Access Compliance Report

Public Rights-of-Way

Intersection ID: 49505	Main Street: ADEL_LN	Cross Street: OSCEOLA_LN	Location: NE
ADA ID: 755BD548A066	Ramp Type: PerpDiag	Initial Pass/Fail: Fail	Overall Compliance: No
Severity Score: 13.75			
Codes/Mitigation Info/Possible Solution		Field Measurements/Component Compliance

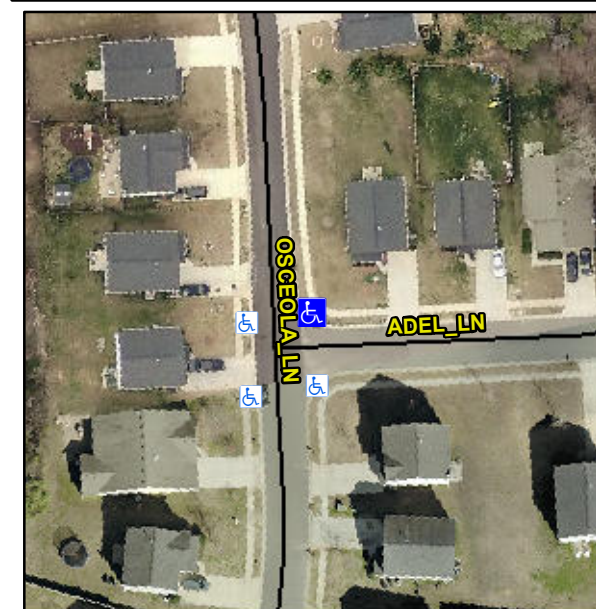
Not Found, R304.2.2, R304.5.3

Compliance	Description	Data	Compliance	Description	Data
N/A	Ramp Length (in)	48.0	No	Ramp Slope (%)	9.8
Yes	Ramp Width (in)	48.0	No	Ramp XSlope (%)	5.0
N/A	Flare Type LT	N/A	N/A	Flare Type RT	N/A
N/A	Flare Slope LT (%)	N/A	N/A	Flare Slope RT (%)	N/A
N/A	Flare Traversable LT?	N/A	N/A	Flare Traversable RT?	N/A
N/A	Landing Length (in)	N/A	N/A	DWS Provided?	N/A
N/A	Landing Width (in)	N/A	N/A	DWS Contrast?	N/A
N/A	Landing Slope (%)	N/A	N/A	DWS Length (in)	N/A
N/A	Landing X Slope (%)	N/A	N/A	DWS Full Width?	N/A
N/A	Landing Curb? (Y/N)	N/A	N/A	DWS Offset (in)	N/A
N/A	Shared Landing?	N/A			
N/A	Gutter Ponding?	N/A	N/A	Gutter Slope (%)	N/A
N/A	Gutter Lip Ht (in)	N/A	N/A	Gutter X Slope (%)	N/A
N/A	Painted X Walk1?	No	N/A	Painted X Walk2?	No
	X Walk 1 Direction	To W		X Walk 2 Direction	To S
N/A	X Walk 1 Width (in)	N/A	N/A	X Walk 2 Width (in)	N/A
	X Walk 1 Slope (%)	1.9		X Walk 2 Slope (%)	2.4
	X Walk 1 X Slope (%)	1.7		X Walk 2 X Slope (%)	4.2

Remove & Replace Curb Ramp With Two New Directional Ramps or Equivalent.
